Contract No. T201804301.01
Federal Aid Project No. NH-S018(18)
Georgetown East Gateway Improvements
Sussex County

Enclosed is Addendum No. 2 for the referenced contract consisting of the following:

UTILITY RELOCATION PLAN	
SECTION	UT-02
WRA	
SHEET NO.	139

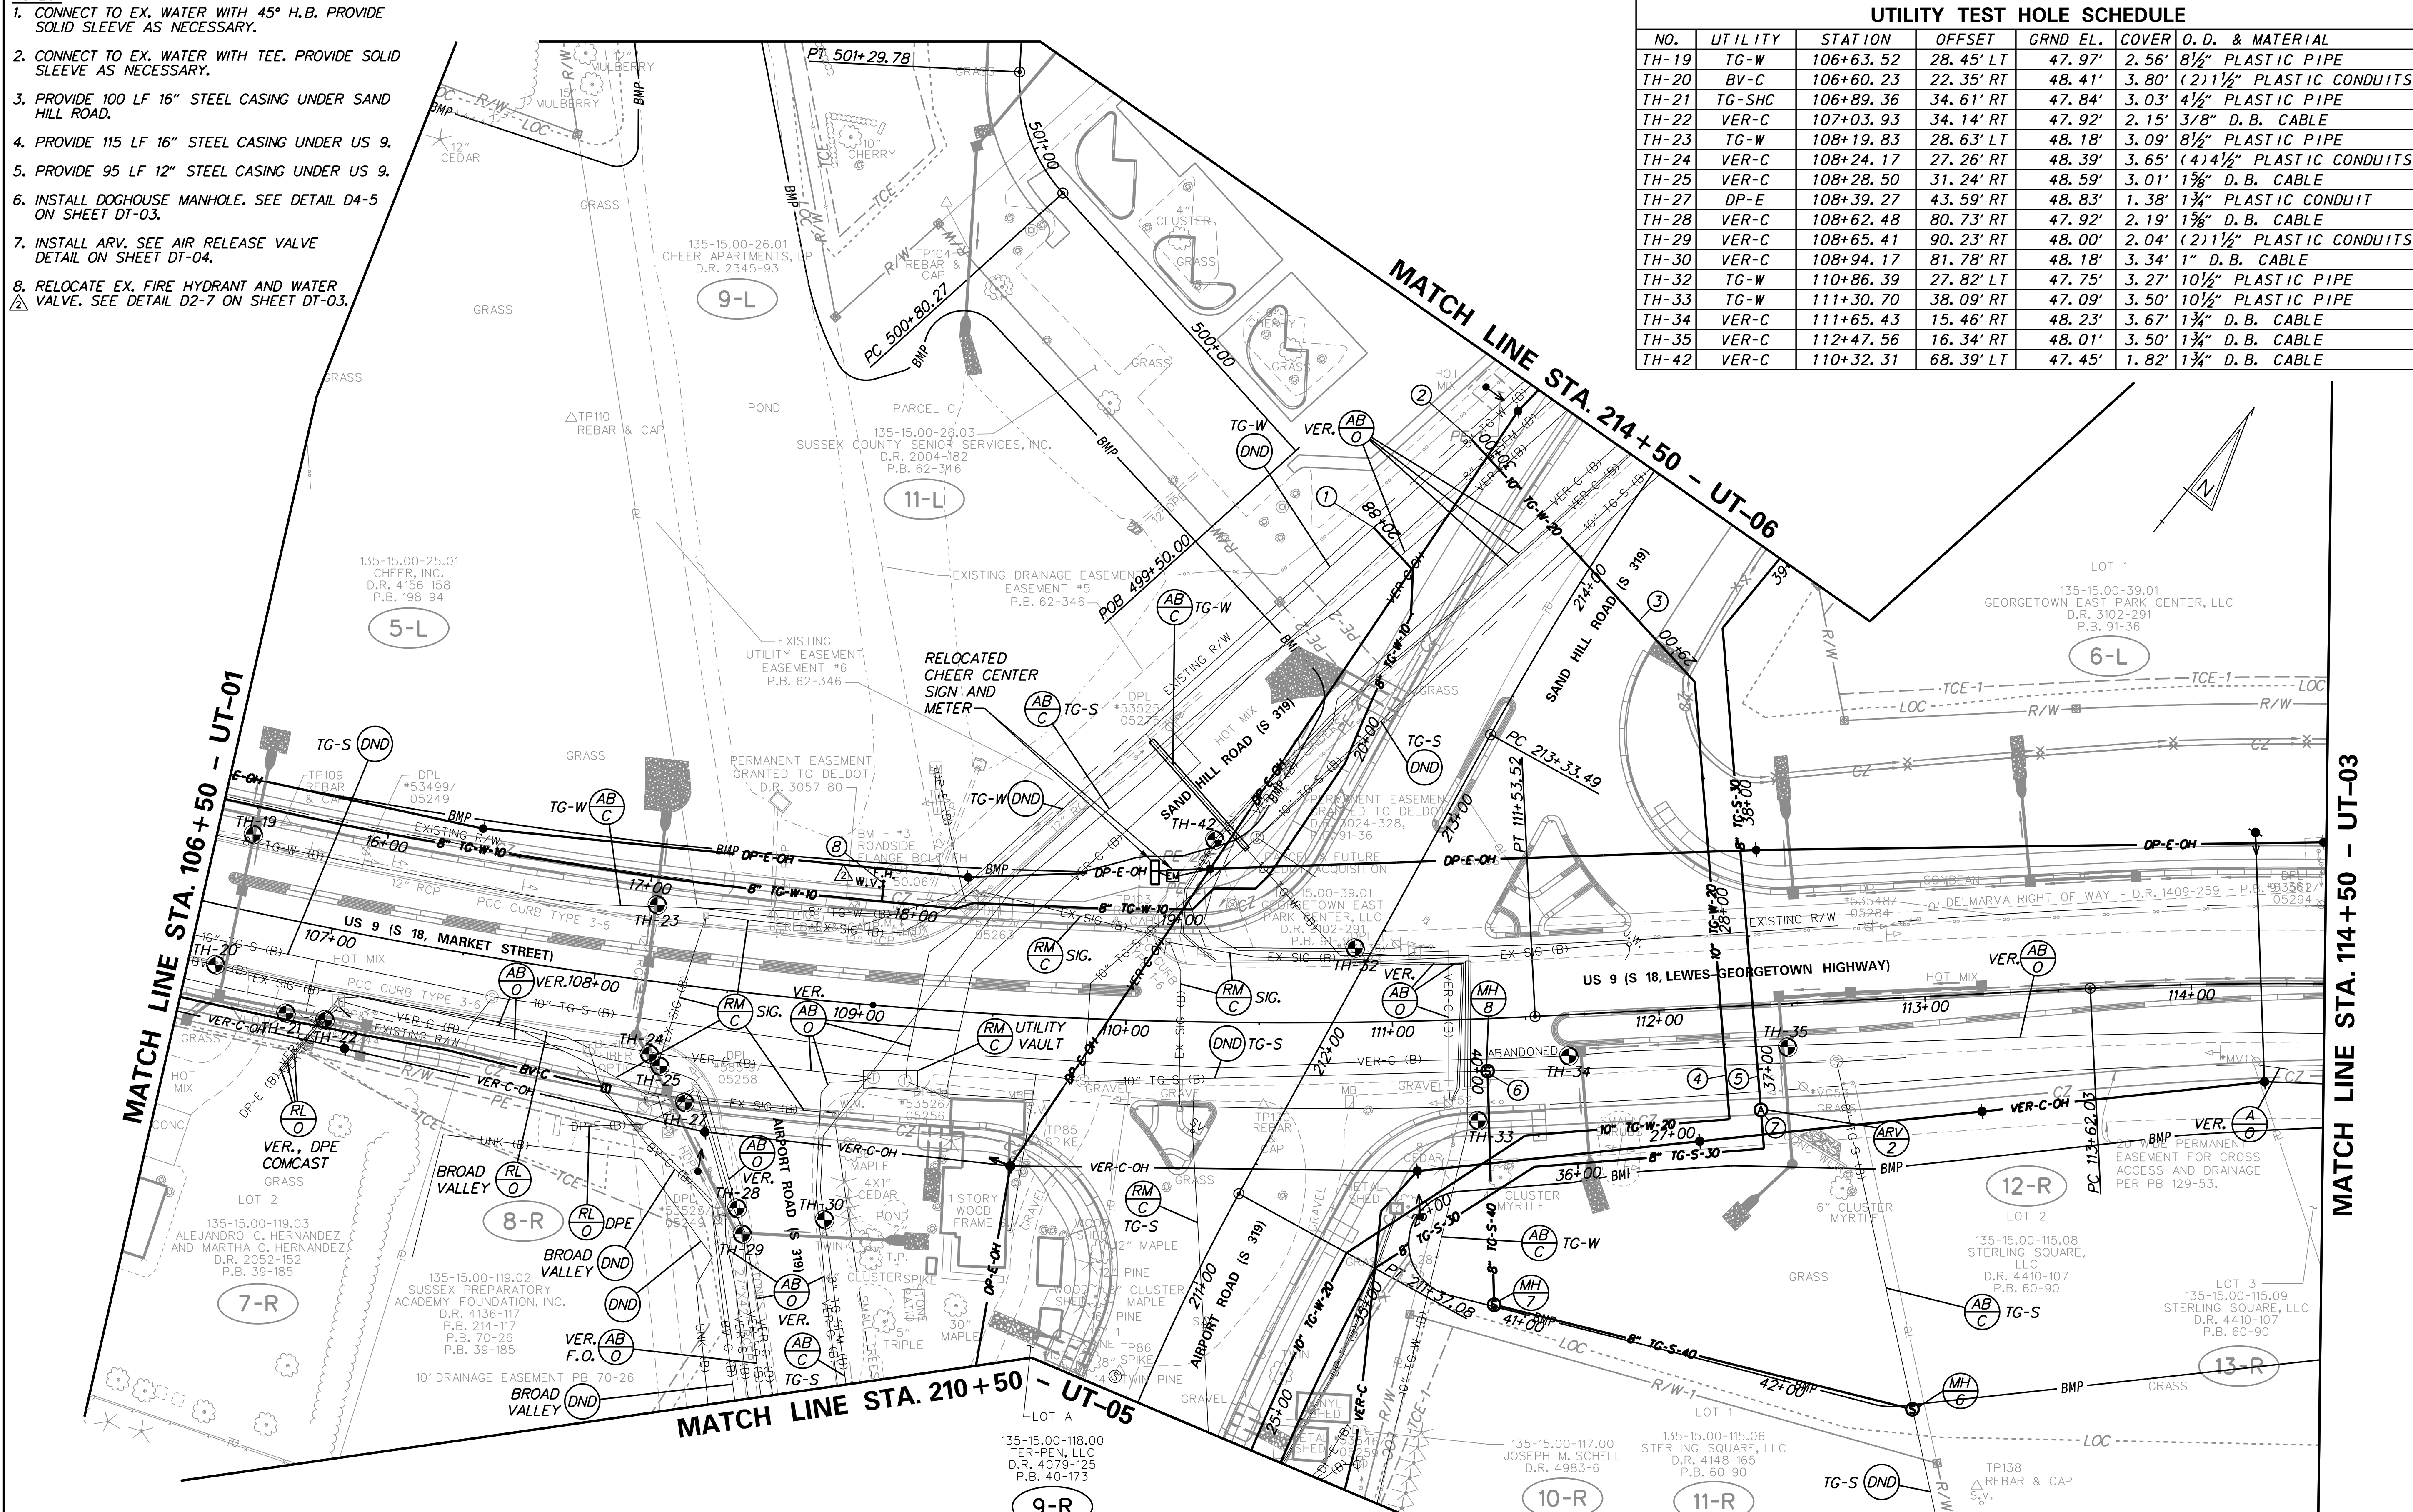
- CONNECT TO EX. WATER WITH 45° H.B. PROVIDE SOLID SLEEVE AS NECESSARY.
- CONNECT TO EX. WATER WITH TEE. PROVIDE SOLID SLEEVE AS NECESSARY.
- PROVIDE 100 LF 16" STEEL CASING UNDER SAND HILL ROAD.
- PROVIDE 115 LF 16" STEEL CASING UNDER US 9.
- PROVIDE 95 LF 12" STEEL CASING UNDER US 9.
- INSTALL DOGHOUSE MANHOLE. SEE DETAIL D4-5 ON SHEET DT-03.
- INSTALL ARV. SEE AIR RELEASE VALVE DETAIL ON SHEET DT-04.
- RELOCATE EX. FIRE HYDRANT AND WATER VALVE. SEE DETAIL D2-7 ON SHEET DT-03.

ADDENDA / REVISIONS	
1	ADDED FIRE HYDRANT AND WATER VALVE. ADDED NOTE 8. R. WILLS - 5/1/20

SECTION	UT-06
WRA	
SHEET NO.	143

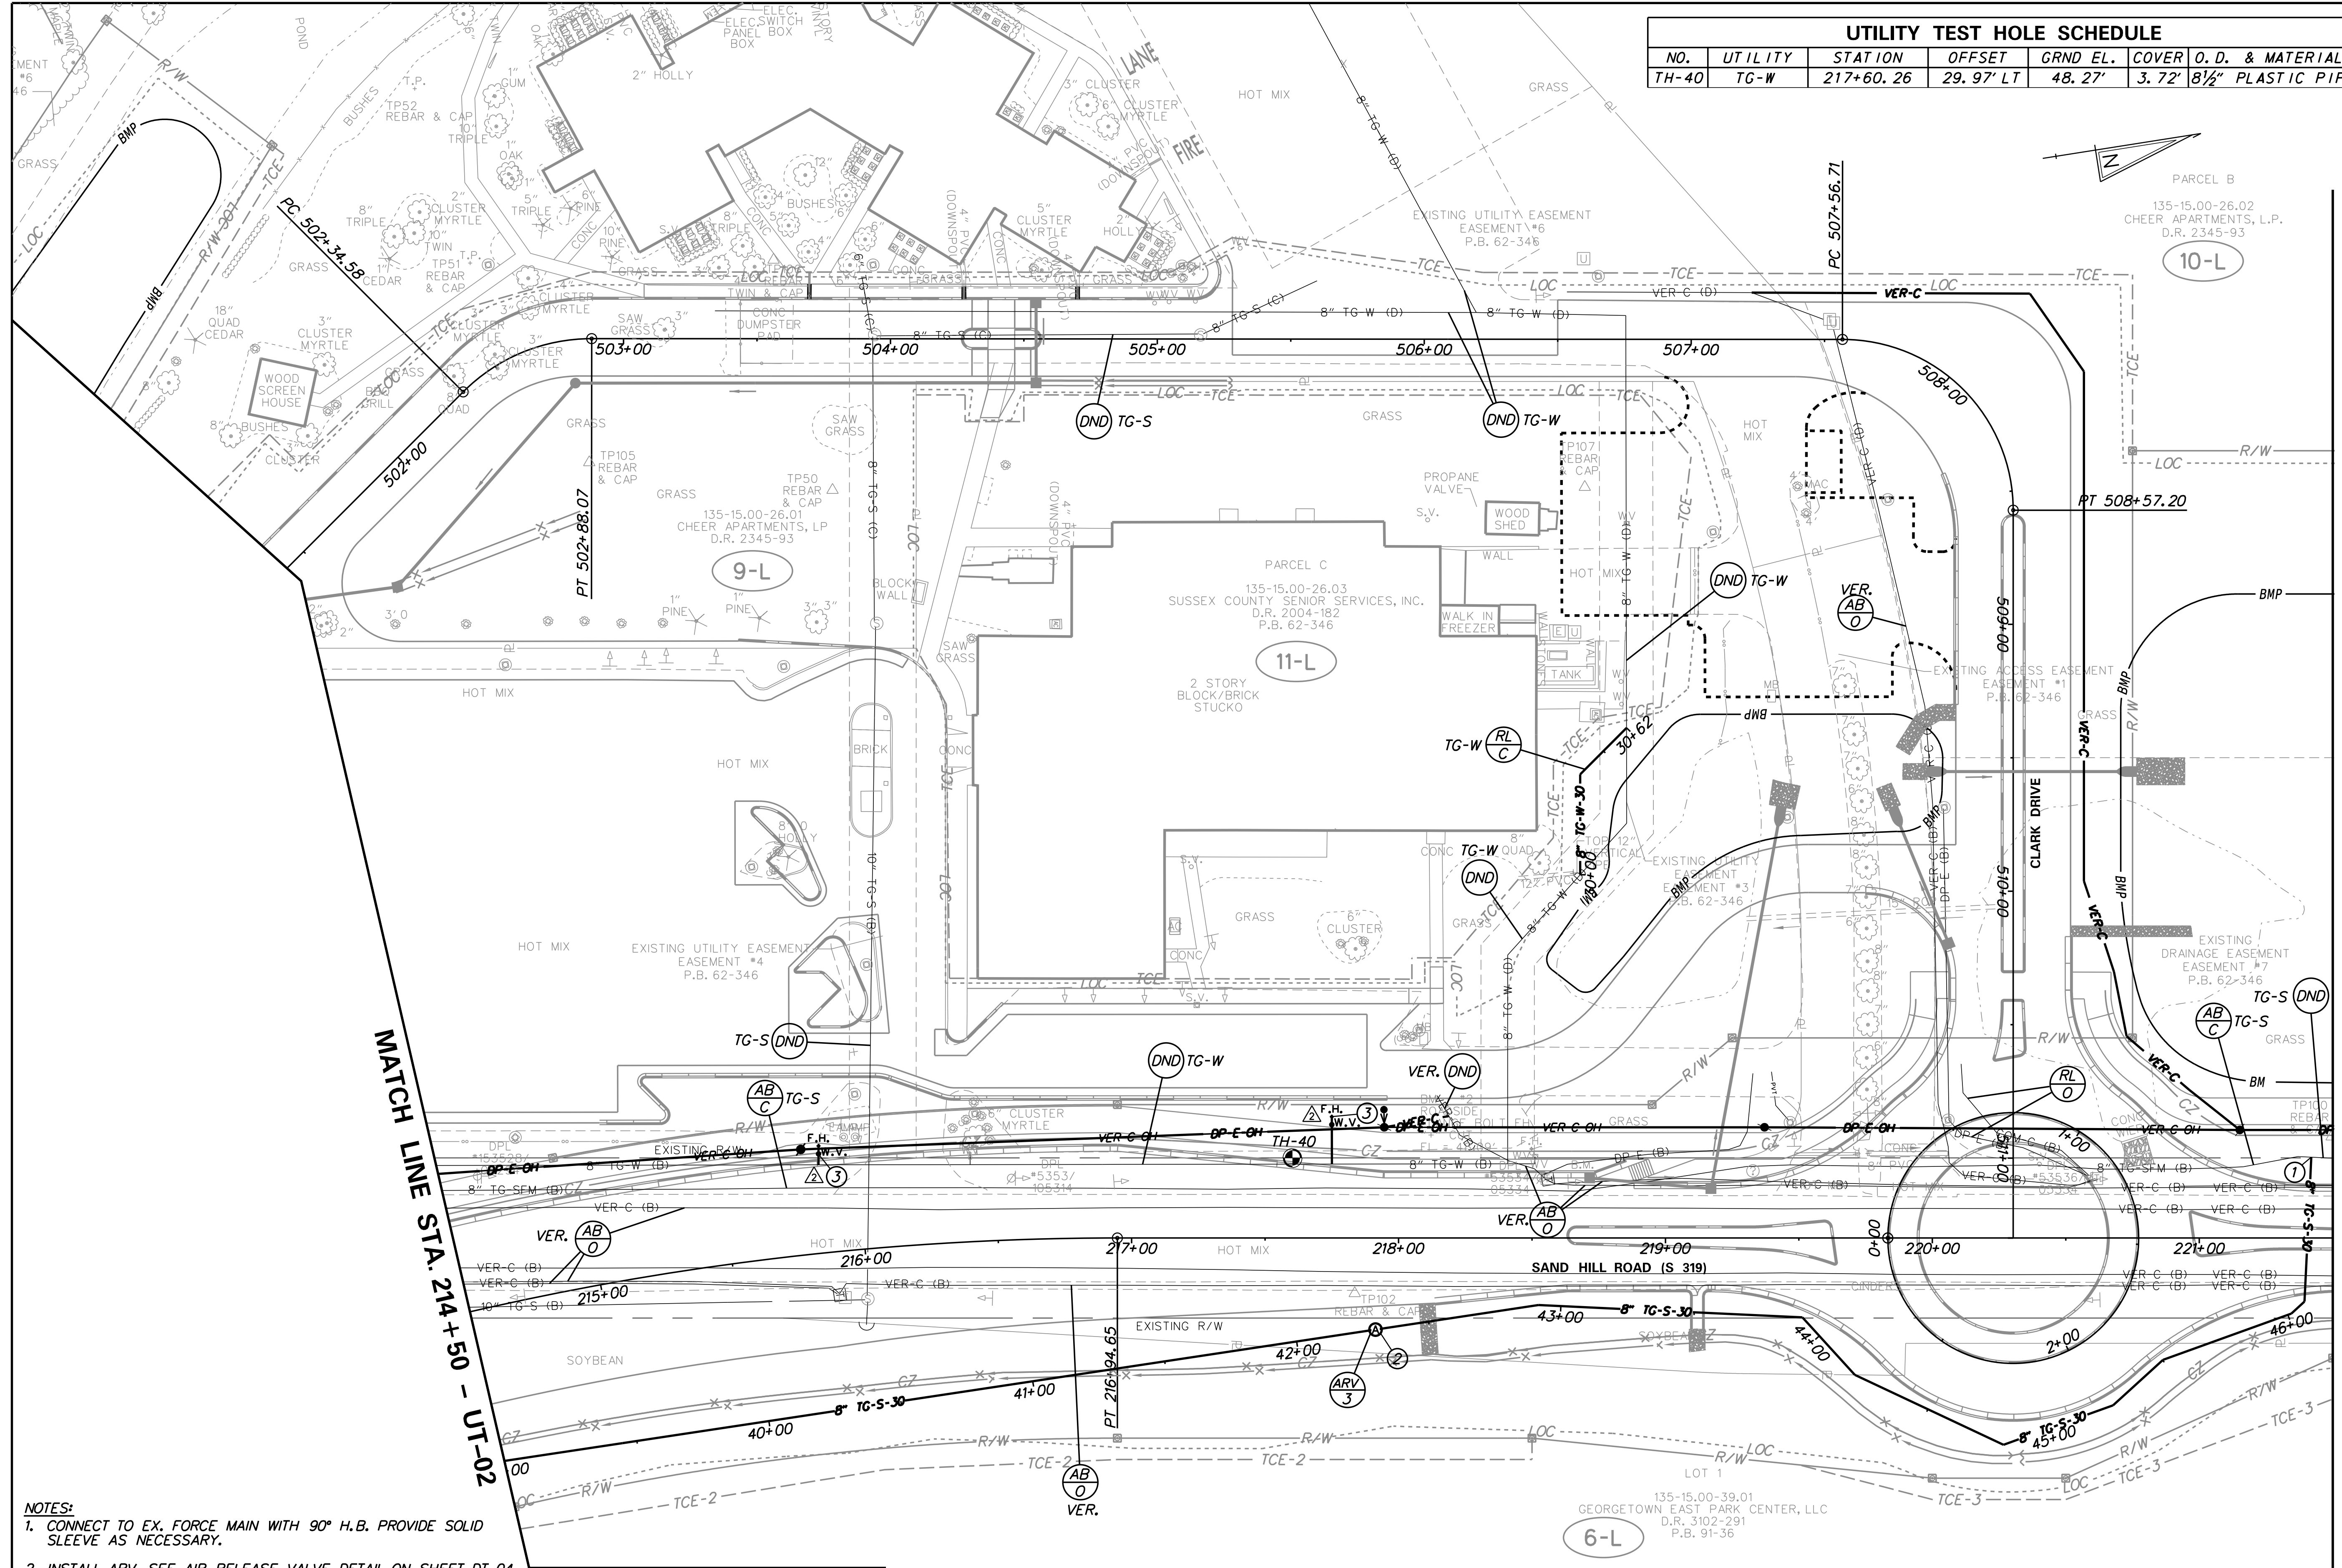
- NOTES:**
- CONNECT TO EX. FORCE MAIN WITH 90° H.B. PROVIDE SOLID SLEEVE AS NECESSARY.
 - INSTALL ARV. SEE AIR RELEASE VALVE DETAIL ON SHEET DT-04.
 - RELOCATE EX. FIRE HYDRANT AND WATER VALVE. SEE DETAIL D2-7 ON SHEET DT-03.

1	ADDED FIRE HYDRANT AND WATER VALVE. ADDED NOTE 3. R. WILLS - 5/1/20
---	---

SIGNING, STRIPING, AND CONDUIT PLAN	
SECTION	WRA
SHEET NO.	152

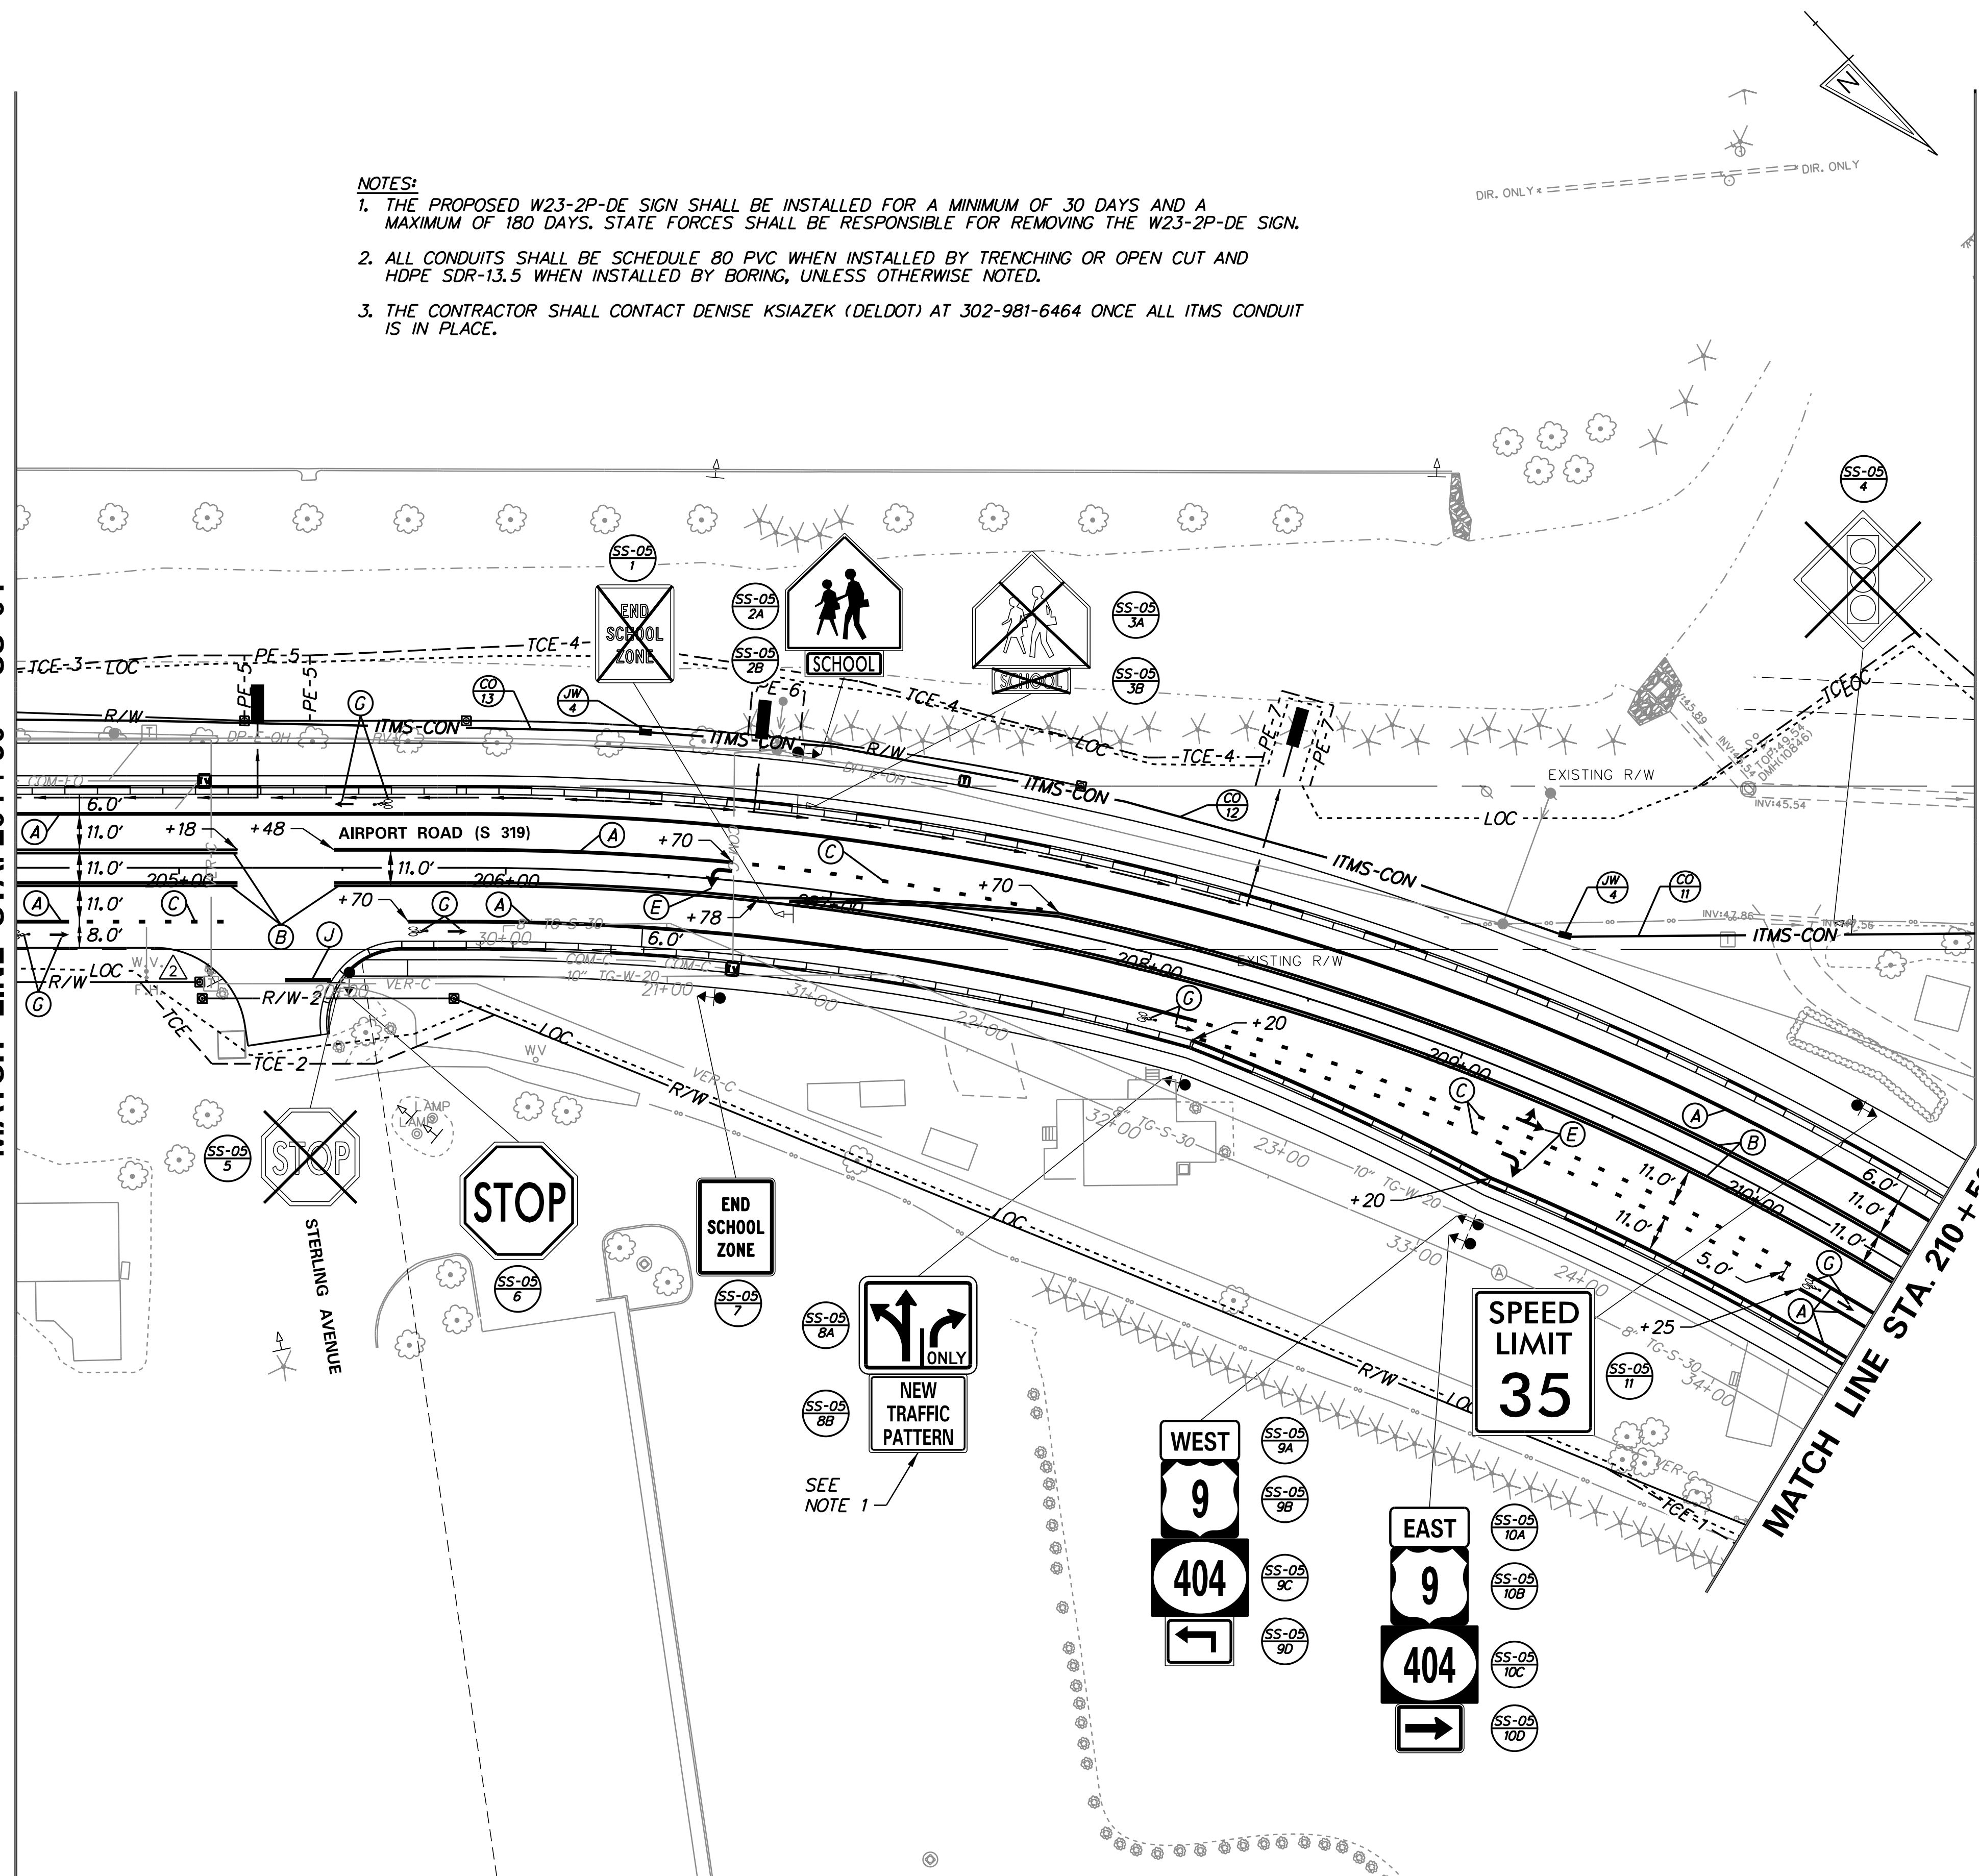
ADDENDA / REVISIONS	
1	ADDED FIRE HYDRANT AND WATER VALVE. R. WILLS - 5/1/20
